Definition of aysmax

Definition of aysmax

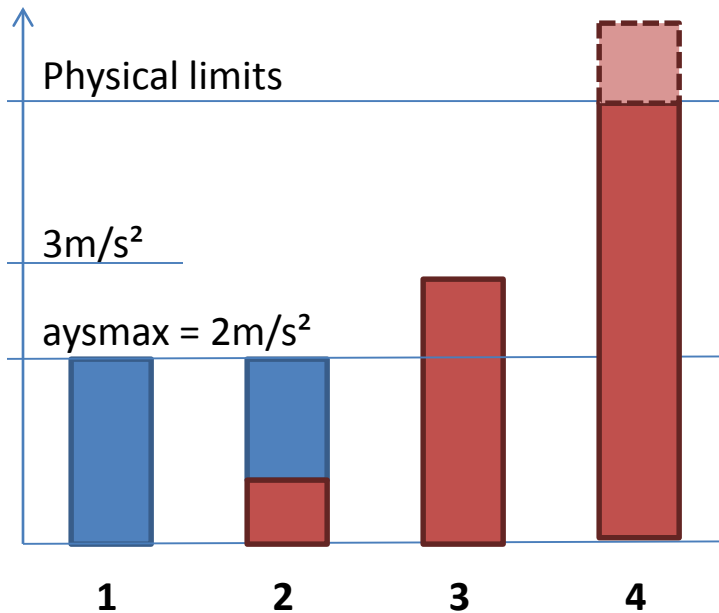
2.4.8.zz "Specified maximum lateral acceleration a_{ysmax} " means the maximum lateral acceleration [of the vehicle] up to which an ACSF is designed to operate.

2.4.8.zz "Specified maximum lateral acceleration a_{ysmax} " means the maximum lateral acceleration ~~up to which an ACSF is designed to operate~~ that an ACSF system is able to generate.
